Access Compliance Report

Public Rights-of-Way

(Curb Ramps)

Intersection ID: 8413	Main Street: CROMER_ST	Cross Street: GOSSETT_AV	Location: NW
ADA ID: 11AFA7280167	Ramp Type: Perp	Initial Pass/Fail: Fail	Overall Compliance: No
Codes/Mitigation Info/Possible Solution		Field Measurements/Component Compliance

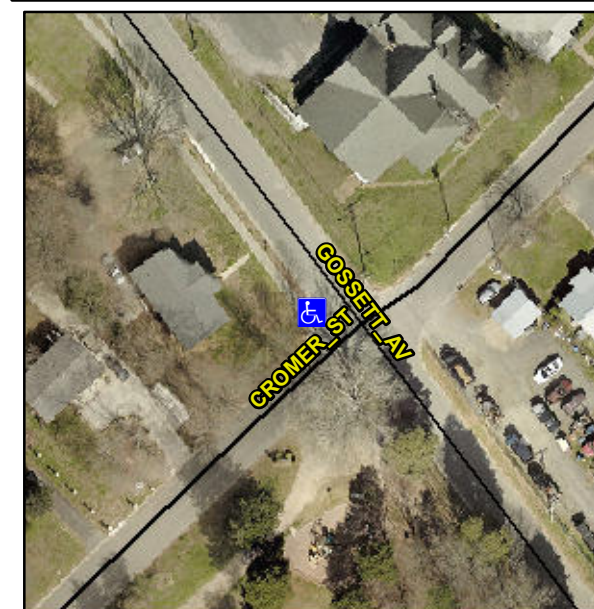
Not Found, R304.5.1, R304.5.3

Compliance	Description	Data	Compliance	Description	Data
N/A	Ramp Length (in)	26.0	Yes	Ramp Slope (%)	5.9
No	Ramp Width (in)	47.0	No	Ramp XSlope (%)	2.2
N/A	Flare Type LT	N/A	N/A	Flare Type RT	N/A
N/A	Flare Slope LT (%)	N/A	N/A	Flare Slope RT (%)	N/A
N/A	Flare Traversable LT?	N/A	N/A	Flare Traversable RT?	N/A
N/A	Landing Length (in)	N/A	N/A	DWS Provided?	N/A
N/A	Landing Width (in)	N/A	N/A	DWS Contrast?	N/A
N/A	Landing Slope (%)	N/A	N/A	DWS Length (in)	N/A
N/A	Landing X Slope (%)	N/A	N/A	DWS Full Width?	N/A
N/A	Landing Curb? (Y/N)	N/A	N/A	DWS Offset (in)	N/A
N/A	Shared Landing?	N/A			
N/A	Gutter Ponding?	N/A	N/A	Gutter Slope (%)	N/A
N/A	Gutter Lip Ht (in)	N/A	N/A	Gutter X Slope (%)	N/A
N/A	Painted X Walk1?	No	N/A	Painted X Walk2?	N/A
	X Walk 1 Direction	To S		X Walk 2 Direction	N/A
N/A	X Walk 1 Width (in)	N/A	N/A	X Walk 2 Width (in)	N/A
	X Walk 1 Slope (%)	0.5		X Walk 2 Slope (%)	N/A
	X Walk 1 X Slope (%)	1.4		X Walk 2 X Slope (%)	N/A

Remove & Replace Entire Ramp.
